URGENT - Field Safety Notice IPX1 Rating Symbol Label Issue

IPX1 Rating Symbol Printed on various Coil Labels

Figure 1. Example label showing IPX1 symbol (red box)

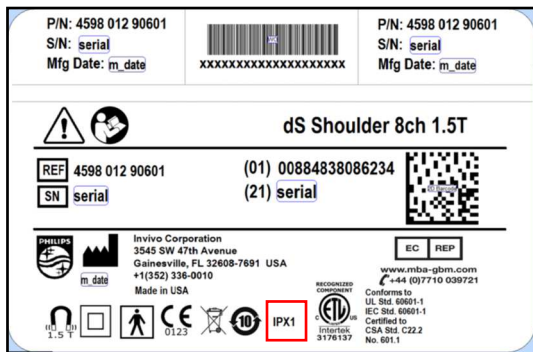
To summarize this notification, the labeling on the affected coils listed on Page 2 of this notice incorrectly contains a printed symbol: IPX1 (see Figure 1 for an example). The product requirements for these coils does not require this type of rating. Unfortunately, an error occurred that allowed the inclusion of this symbol on the product label. The inclusion of this rating symbol does not affect form, fit, or function of these coils and poses no risk to user or patient safety.

HAZARD INVOLVED	The labeling non-conformance is not a potential hazard to Users or Patients.			
HOW TO IDENTIFY AFFECTED PRODUCTS	Products manufactured from November 2016 contain this easily identifiable symbol on its label (see Figure 1) and are in the scope of this field action.			
ACTION TO BE TAKEN BY CUSTOMER / USER	Although the symbol on the label should not be have been included, the device poses no risk to users of these devices nor patients. Customers need take no action other than the following: <ul style="list-style-type: none"> Notify all members of your staff who need to be aware of the contents of this communication. 			
ACTIONS PLANNED BY PHILIPS	Corrective and Preventative Actions are being implemented to ensure this type of non-conformance does not occur in the future. Immediate corrections are taking place to remove IPX1 symbols from labels for future use. This notice is being distributed to Customers who have affected products installed at their sites.
